COUNCIL ASSESSMENT REPORT

Panel Reference	PPSSNH-358
DA Number	134/2022
LGA	Lane Cove Council
Proposed Development	<p>Seniors Housing, comprising:</p> <ul style="list-style-type: none"> • Demolition of the seven (7) existing buildings on the site containing existing 52 aged care units and removal of vegetation as necessary. • Construction of two buildings (Building A on Lot 120 and Building B on Lot 51) of 6 storeys and 4 storeys in height respectively containing: <ul style="list-style-type: none"> - 52 Independent Living Apartments - Associated facilities (i.e. ground floor lobby and reception area; sales office; resident kitchen, café and undercover barbeque area; outdoor communal, outdoor open space areas - Parking for 53 vehicles in a single basement level
Street Address	40A Cope Street Lane Cove
Applicant/Owner	Retire Australia (Lane Cove) Pty Ltd - Applicant and land owner
Date of DA lodgement	DA lodged: 28 October 2022

Report prepared by	Robert Montgomery, Principal Montgomery Planning Solutions (Independent Consultant)
Report date	16 August 2023

Figure 9: Southern elevation. Source: Architectural plans

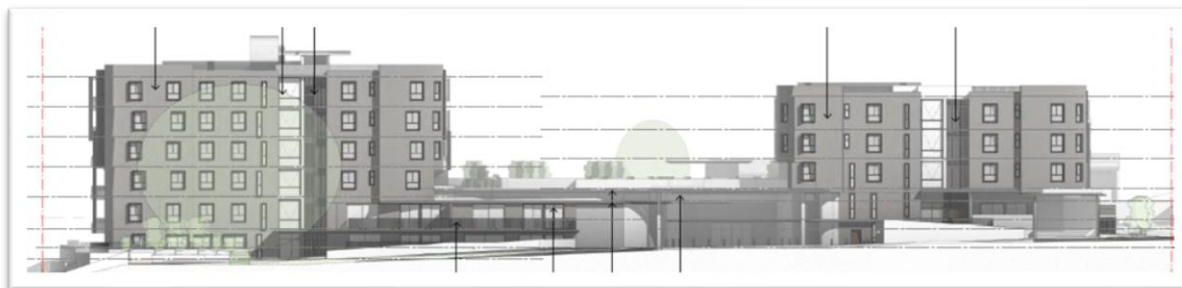
The proposal is designed to present as two separate buildings, joined by a podium from level 2 of Building A to level 1 of Building B. The westernmost building on Lot 120 (Building A) is six (6) storeys, while the easternmost building on Lot 51 (Building B) is four (4) storeys. The podium which joins the building provides some 616m² of communal open space, comprising a large level space with planter boxes.

Figure 14: Height Plane Diagram. Source: Applicant's SEE

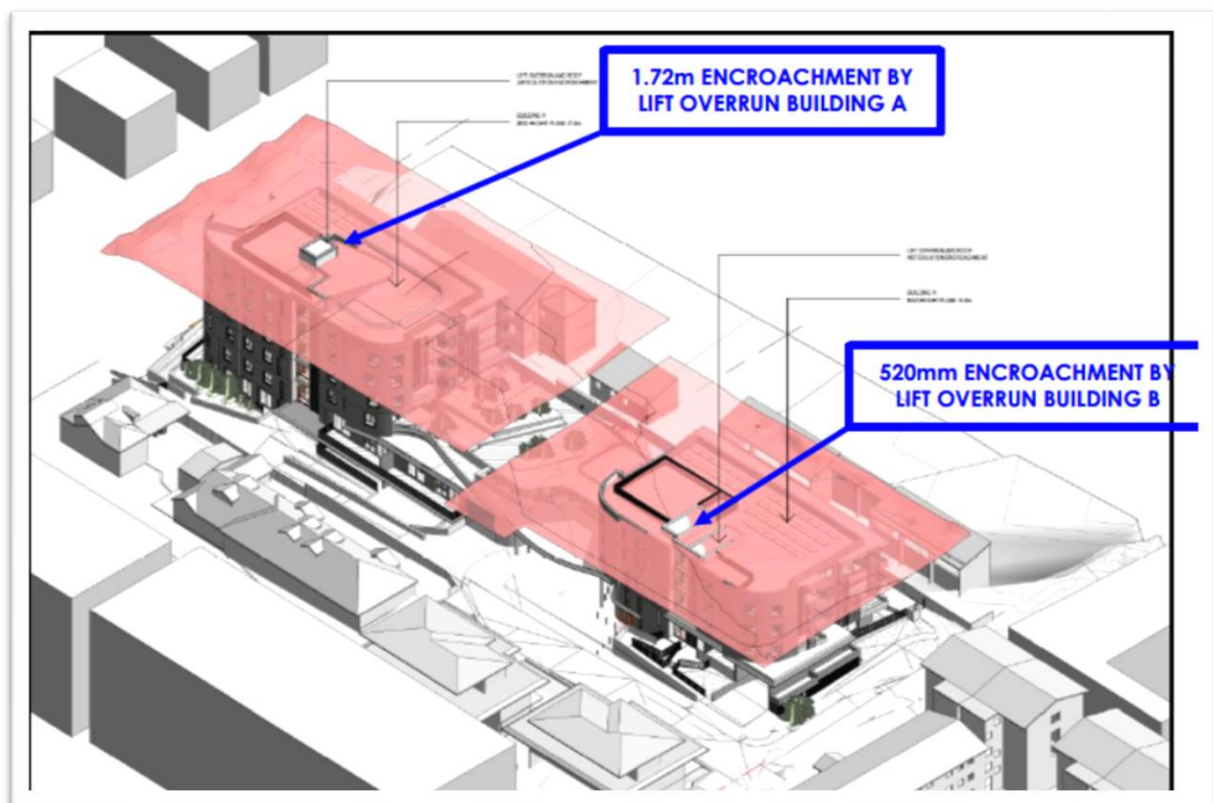
The applicant submits that the height contraventions relate to lift overruns only, and no additional floor space is created. The applicant argues that the objectives of the standard are achieved notwithstanding non-compliance with the standard. In support of this argument it is submitted that:

The applicant also presents a list of environmental planning grounds to justify contravention of the development standard, however, it is considered that the grounds provided do not justify contravening the height standard.

In other circumstances, a lift overrun height contravention may be able to be justified. However, the grounds submitted by the applicant only provide justification for the additional 3.8m building height provided by the Housing SEPP, not a further non-compliance.

It is considered that the applicant has not demonstrated that compliance with the building height development standard is unreasonable or unnecessary, nor have sufficient environmental planning grounds be provided to justify the contravention. Accordingly, it is recommended that the Clause 4.6 request in relation to the height of buildings is not supported.
